Our Case Number: ABP-317767-23

Re: Proposed construction of 39 residential units, widening of Pausdeen Bridge and all associated site works.  
Newtown/Ardclough Road, Newtown, Celbridge, Co. Kildare.

## Planning Observation Submissions to An Bord Pleanála

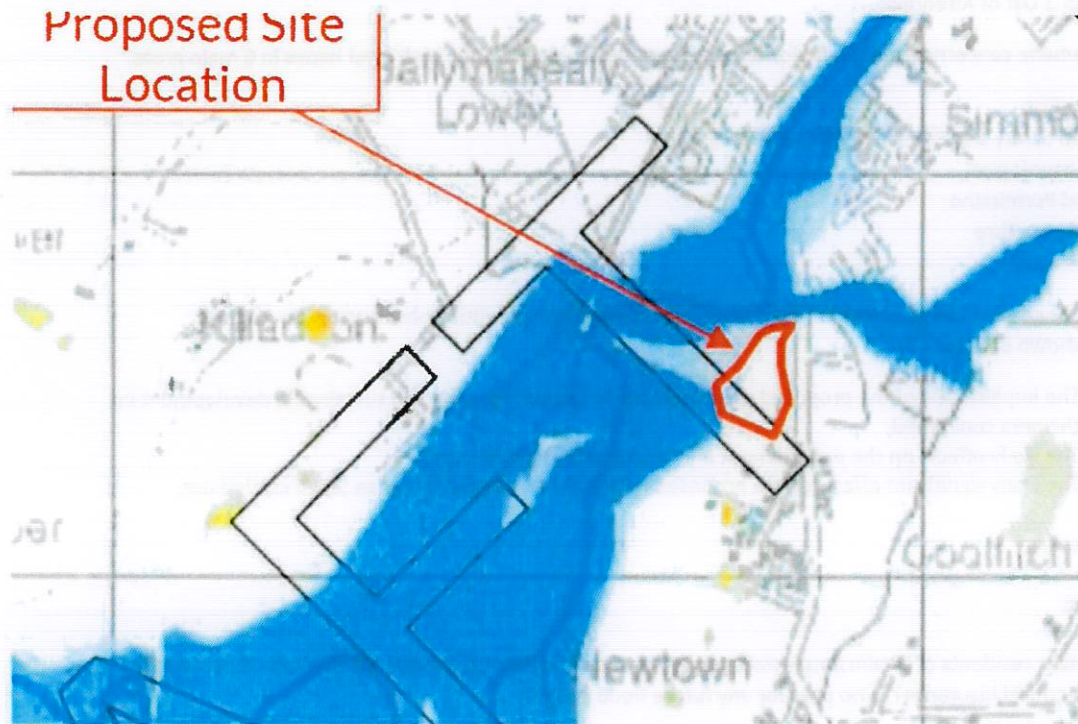
PFRA: Tobin report highlights the OPW Preliminary Flood Assessment (PFRA) and clearly state themselves that there is flooding in the southwest corner of the site.
